THE CITY OF WINNIPEG WATER TREATMENT PLANT  
 CONCEPTUAL YARD PIPING  
 VALVE LOCATION PLAN  
 SK-01- REVISED ADDENDUM 2

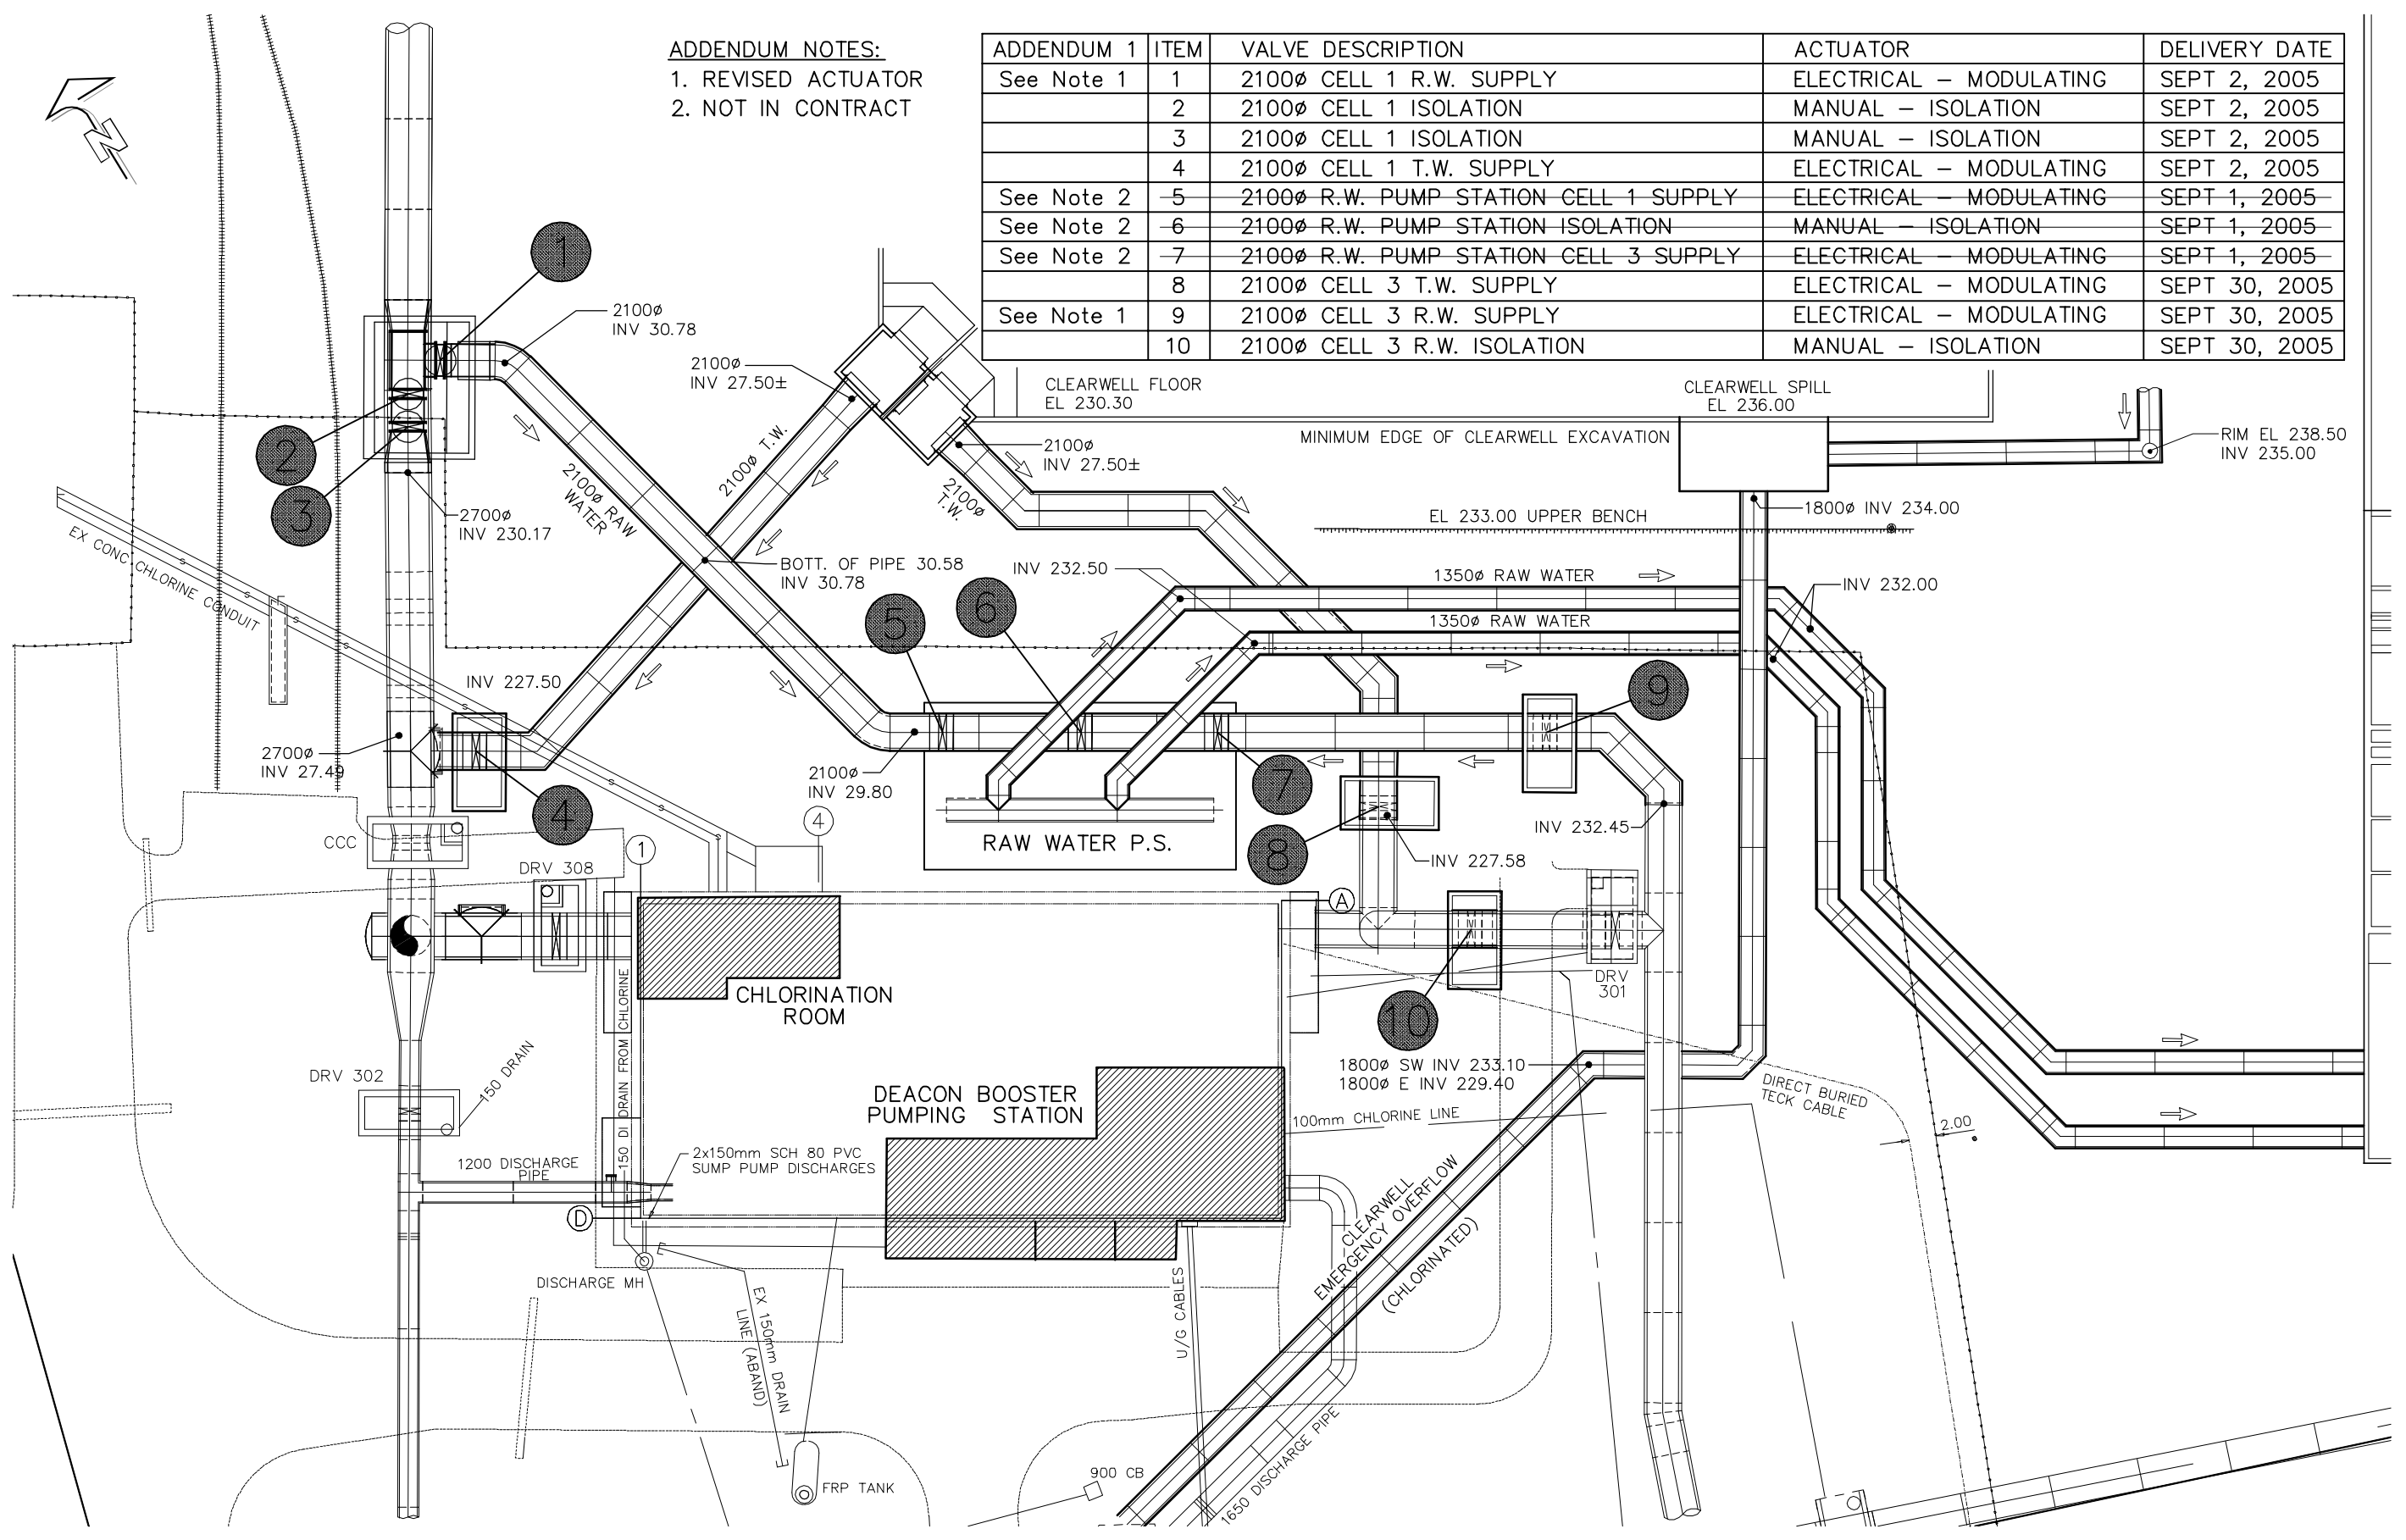
**ADDENDUM NOTES:**  
 1. REVISED ACTUATOR  
 2. NOT IN CONTRACT

ADDENDUM 1	ITEM	VALVE DESCRIPTION	ACTUATOR	DELIVERY DATE
See Note 1	1	2100ø CELL 1 R.W. SUPPLY	ELECTRICAL - MODULATING	SEPT 2, 2005
	2	2100ø CELL 1 ISOLATION	MANUAL - ISOLATION	SEPT 2, 2005
	3	2100ø CELL 1 ISOLATION	MANUAL - ISOLATION	SEPT 2, 2005
	4	2100ø CELL 1 T.W. SUPPLY	ELECTRICAL - MODULATING	SEPT 2, 2005
See Note 2	-5	2100ø R.W. PUMP STATION CELL 1 SUPPLY	ELECTRICAL - MODULATING	SEPT 1, 2005
See Note 2	-6	2100ø R.W. PUMP STATION ISOLATION	MANUAL - ISOLATION	SEPT 1, 2005
See Note 2	-7	2100ø R.W. PUMP STATION CELL 3 SUPPLY	ELECTRICAL - MODULATING	SEPT 1, 2005
	8	2100ø CELL 3 T.W. SUPPLY	ELECTRICAL - MODULATING	SEPT 30, 2005
See Note 1	9	2100ø CELL 3 R.W. SUPPLY	ELECTRICAL - MODULATING	SEPT 30, 2005
	10	2100ø CELL 3 R.W. ISOLATION	MANUAL - ISOLATION	SEPT 30, 2005
